STPN-052-1(113)-2J-49
 U.S. 52
 12/17/24

*U.S. 52 from Mississippi River Bridge
 to
 Overflow Bridge North of Sabula*

FIELD EXAM MEETING MINUTES

Subject: Meeting Minutes
US 52 Causeway D02 Design Field Exam

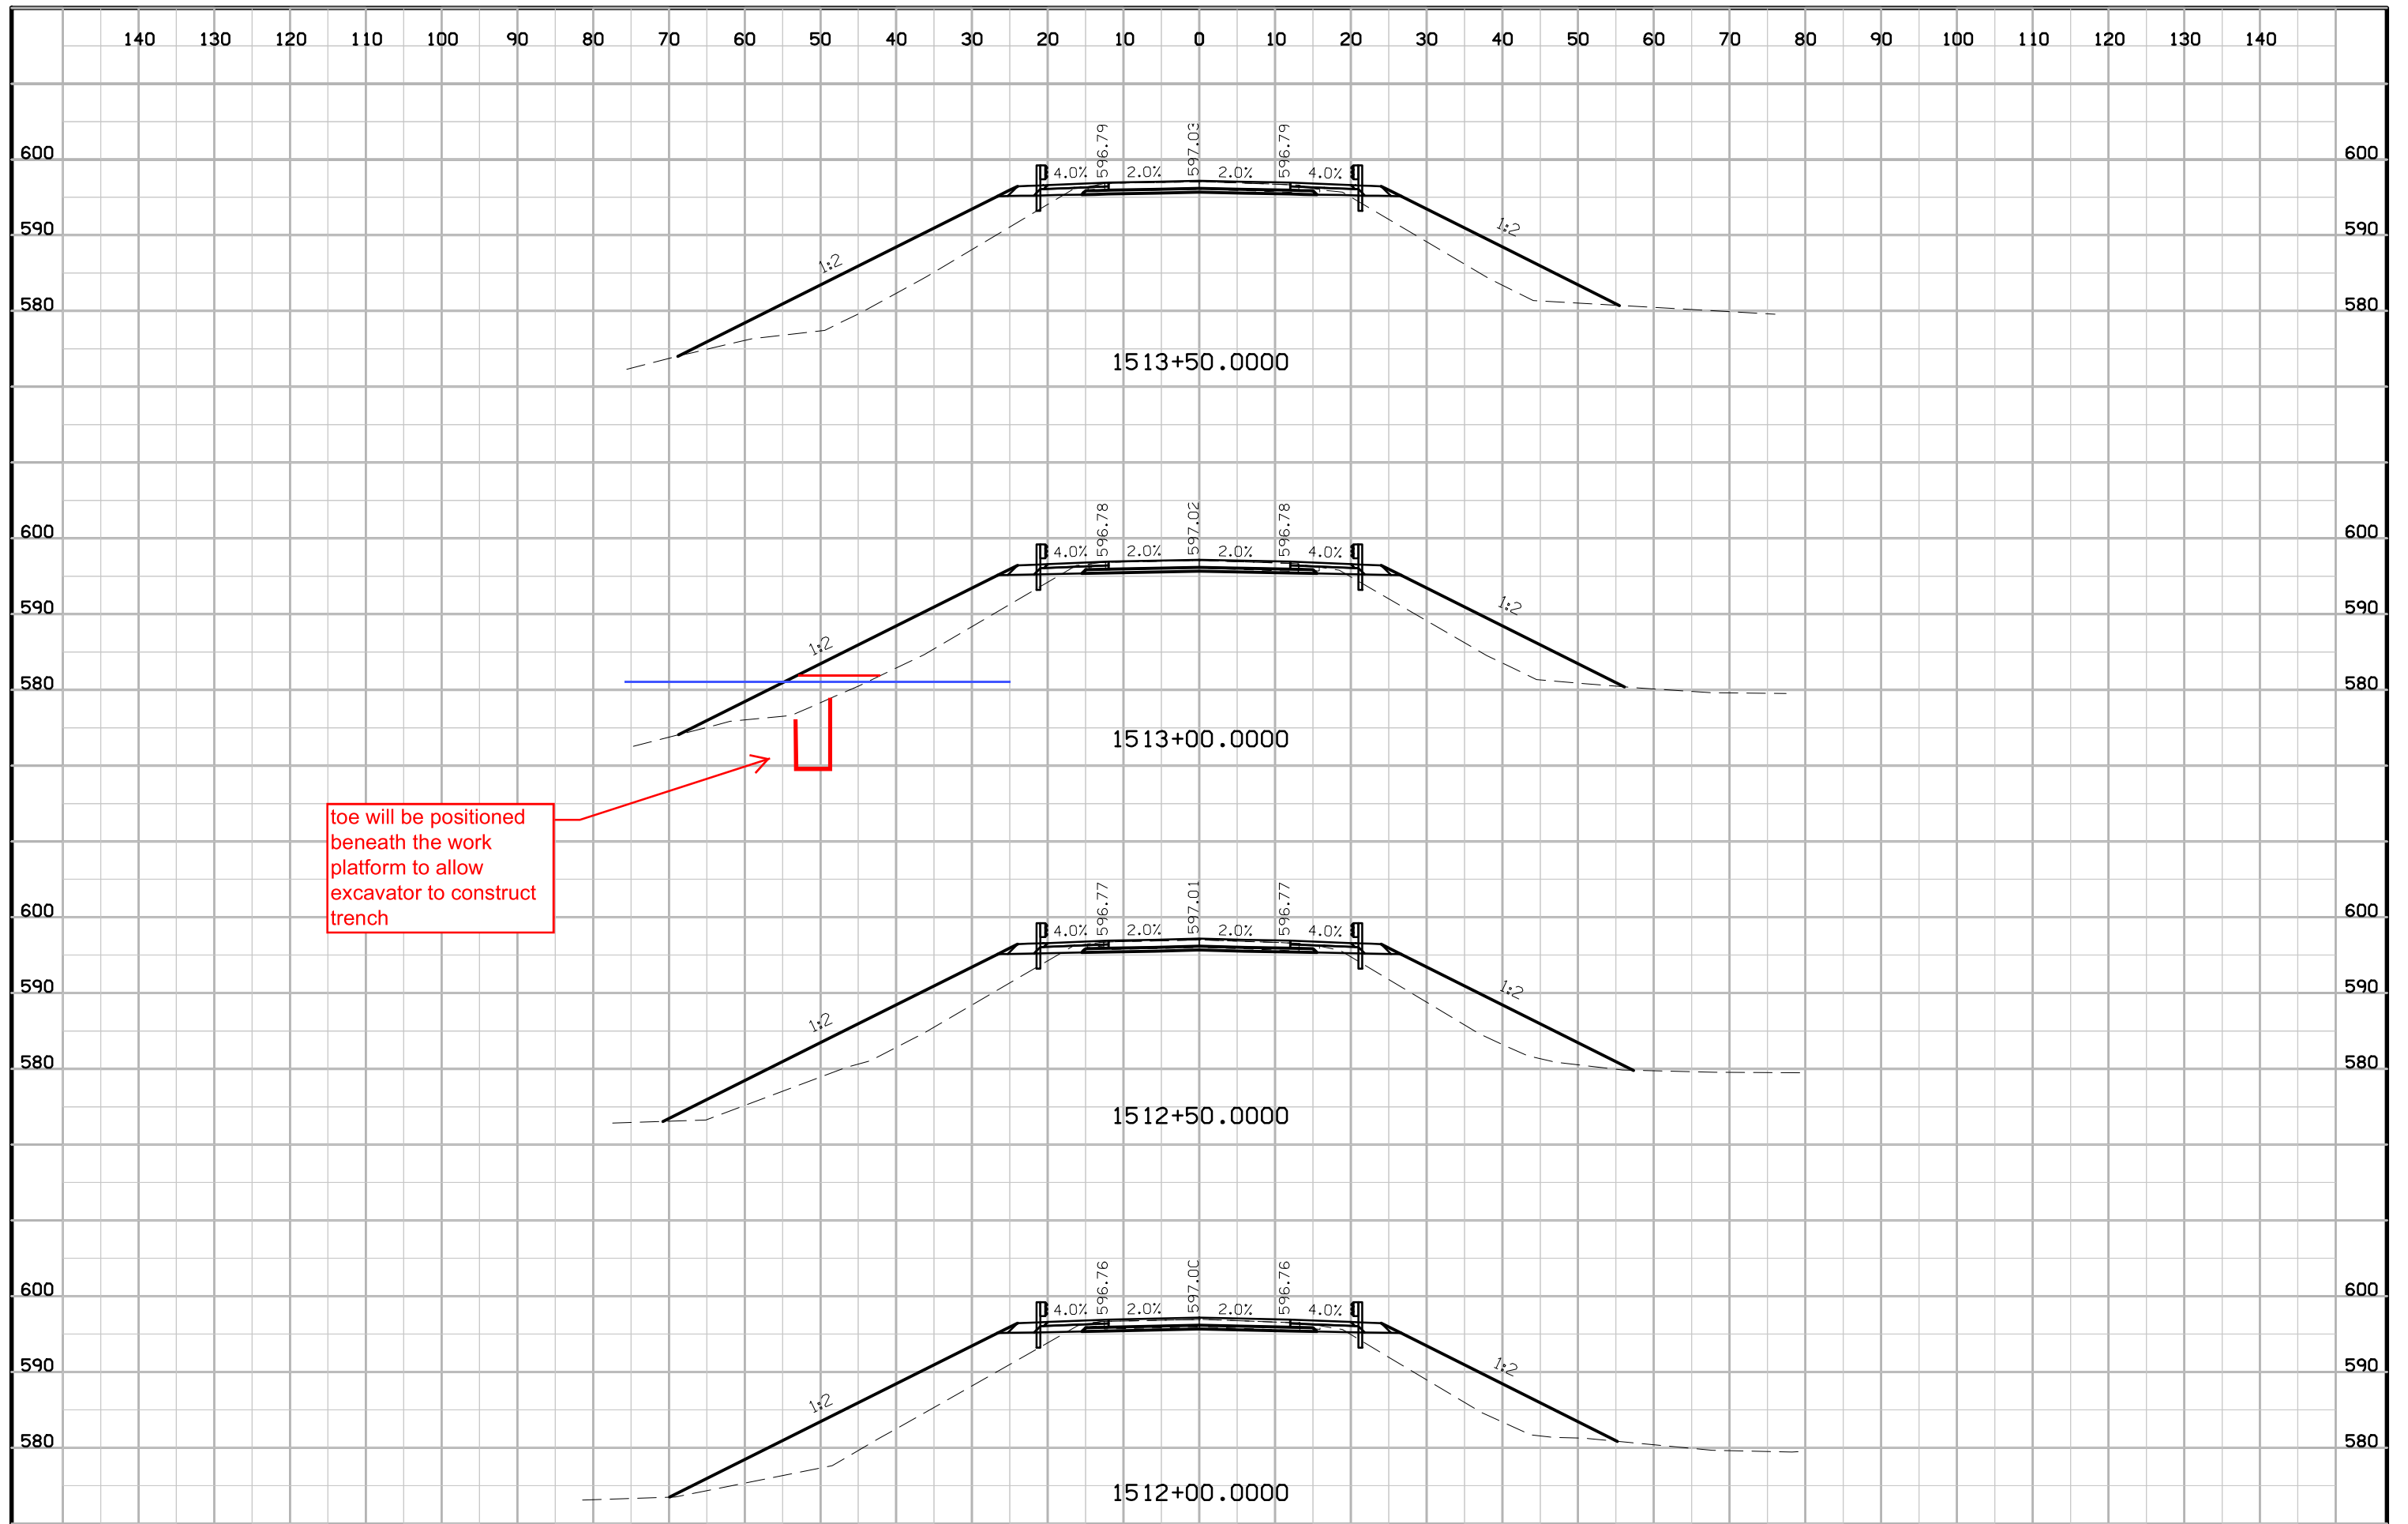
In the past we have considered the use of the Z Boat to gather additional underwater information about the channel bottom

toe will be positioned
beneath the work
platform to allow
excavator to construct
trench
